SAN DIEGO COUNTRY PARKS
AMERICANS WITH DISABILITIES ACT
AUDIT & TRANSITION PLAN
PHASE 2

THE COUNTY OF SAN DIEGO ADA AUDIT AND TRANSITION PLAN PHASE 2

Prepared for:

The County of San Diego Department
Of Parks and Recreation
5500 Overland Avenue
Suite 410
San Diego, CA. 92123

RESTROOM #2

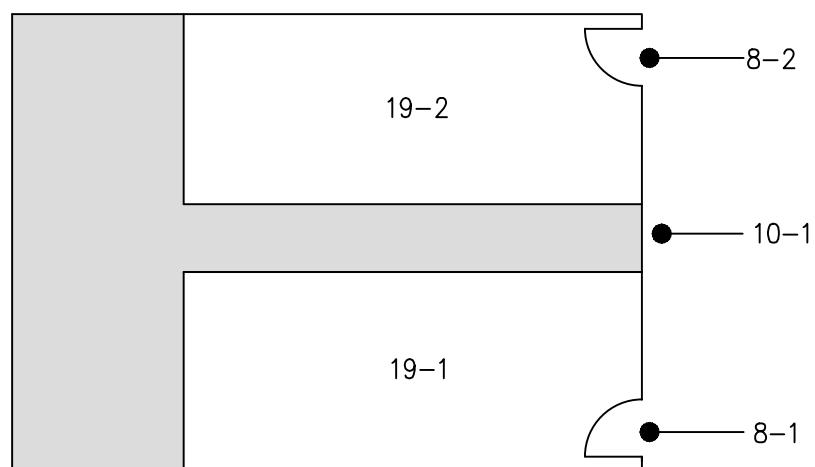
8-1 Door

Add ISA Signage

Remove or Relocate Lav Mirrors

Provide or Replace Stall Door Hardware

Add or adjust door self-closer.
CBC 11B- 604.8.1.2 / ADA 604

Add Grab Bars

Add Rear GB
CBC: 11B-604.5.1 / ADA 604

RANGER STATION

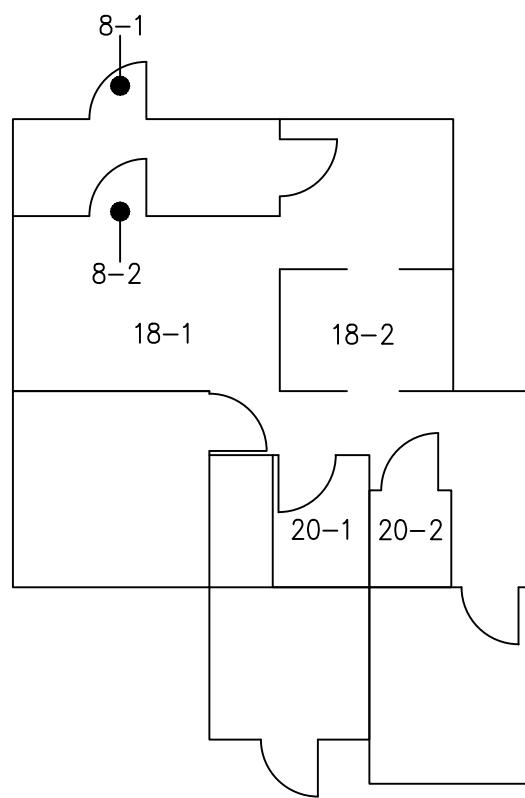
Change 5" tall stoop to a Ramp with max. slope 1:12.

Replace Door Hardware

Change 5" tall stoop to a Ramp with max. slope 1:12.

Replace Door Hardware

Provide an Accessible Counter

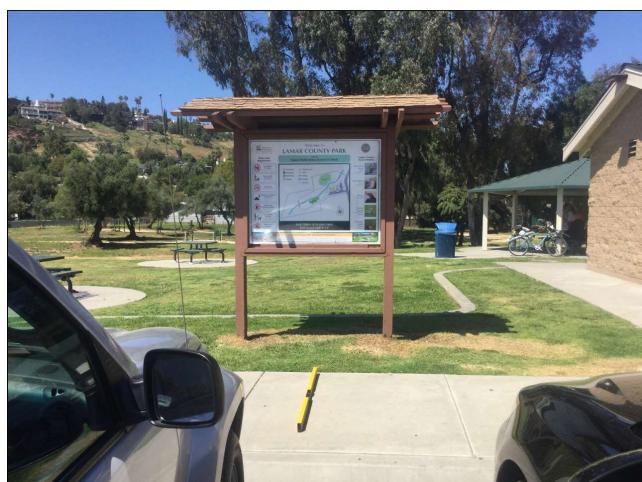
Action: Relocate kiosk closer to accessible path.

CBC: 11B-403.3 - The running slope of walking surface shall not be steeper than 1:20. The cross slope of walking surfaces shall not be steeper than 1:48.

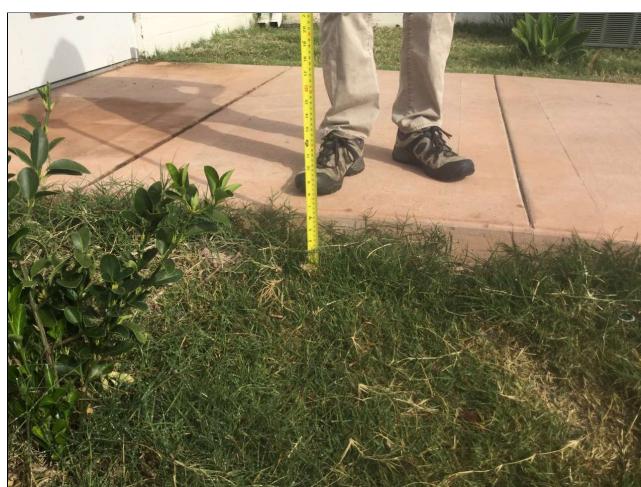
Action: Regrade adjacent surface.

CBC: 11B-303.5 - Vertical falls greater than 4" require warning curb.

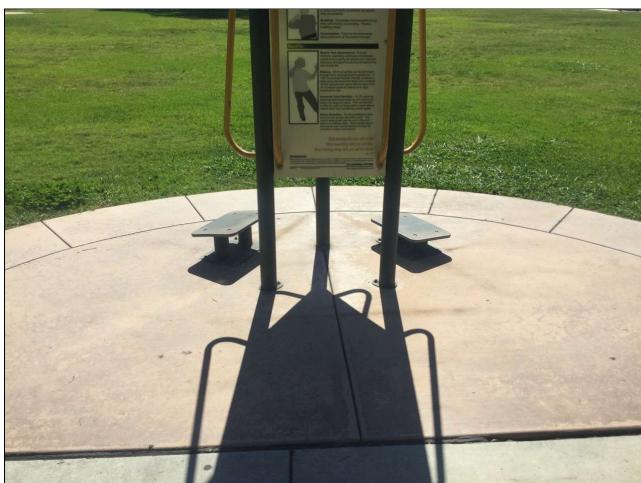
Action: Add sealant to fill gaps.

CBC: 11B-302.3 - Openings in floor or ground surfaces shall not allow passage of a sphere more than $\frac{1}{2}$ inch.

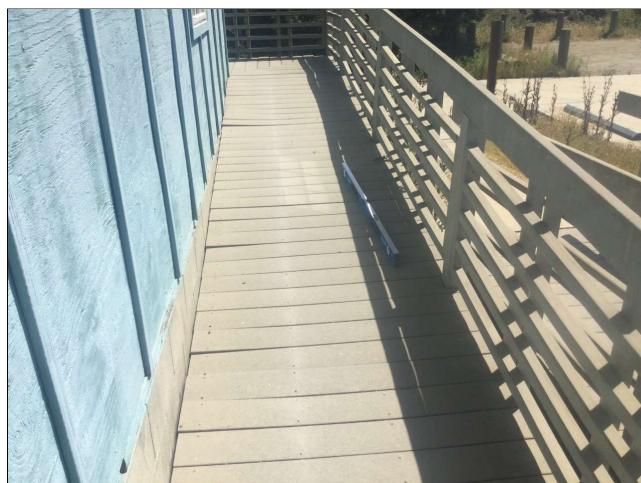
Action: Reconstruct ramp to meet grade.

CBC: 11B-405.2 - Ramps shall have running slope not steeper than 1:12.

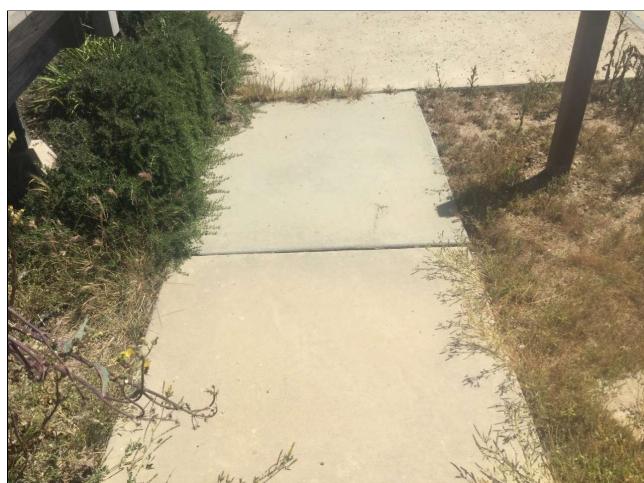
Action: Grind or patch vertical change of grade.

CBC: 11B-303.2 - Vertical changes must be 1/4" max, up to 1/2" with a bevel.
